Interactive comment on “Improving measurements of SF₆ for the study of atmospheric transport and emissions” by B. D. Hall et al.

Response to reviewer #1: AMTD doi:10.5194/amtd-4-4131-2011

Fig. 1. Figure 4 (revised): History of SF₆ precision (%) from all samples analyzed on the GC-ECD systems used for calibrations (color-coded by SF₆ mole fraction (ppt)). Upper plot shows three GC versions.

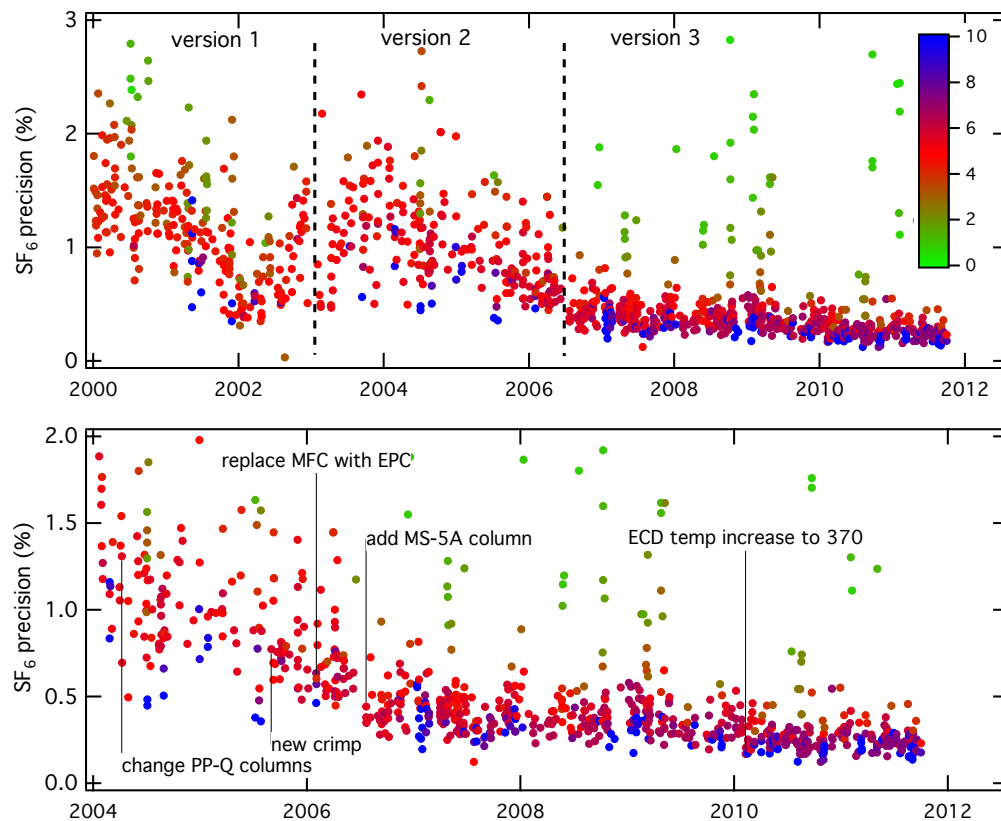
The reviewer notes that the change in SF₆ precision does not seem to be conclusively linked to the addition of the post-column, and could be the result of other factors.

that addition of the post-column was a major factor, and have revised text and Figure 4 to support this argument.

1) We have modified Figure 4 to include all reference gases analyzed on the calibration instruments (color-coded by mole fraction) and added a second panel to expand the period 2004-2011. Here, we have noted changes to the instrument before and after the addition of the post-column.
